# A d d e n d u m

Iowa Department of Transportation  
Office of Contracts

<b>B.O.</b>	<b>Proposal ID</b>	<b>Proposal Work Type</b>	<b>County</b>	<b>Project Number</b>	<b>Addendum</b>
352	31-2100-663	Traffic Signs	Dubuque	SRTS-2100(663)--8U-31	18sep352.a01

SAFE ROUTES TO SCHOOL  
SRTS-U-2100(663)--8U-31

**TELESCOPIC TUBING ANCHORS  
TWO PIECE SYSTEM DETAIL**

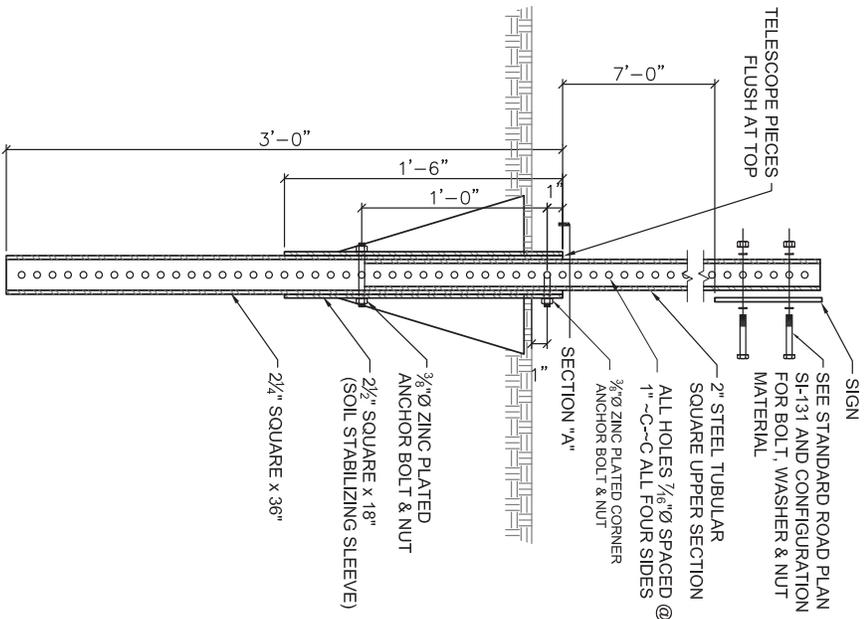
Add the attached SHEET B.02.

Add the following reference note for the item 2524-9265010, POSTS, STEEL, AS PER PLAN:

Refer to the detail on sheet B.02. Method of Measurement: Shall be by each. Basis of Payment: Payment will be at the contract unit price each which is full compensation for furnishing; erecting the posts including other details necessary to provide the sign posts complete and erected in place. All costs to furnish, assemble, deliver and install the telescopic tubing posts and anchors as shown on sheet B.02 shall be incidental.

SIGNS WIDER THAN 3 FEET OR LARGER THAN 9 SQ. FT. SHALL BE MOUNTED ON MULTIPLE POSTS (SEE ABOVE TABLE).
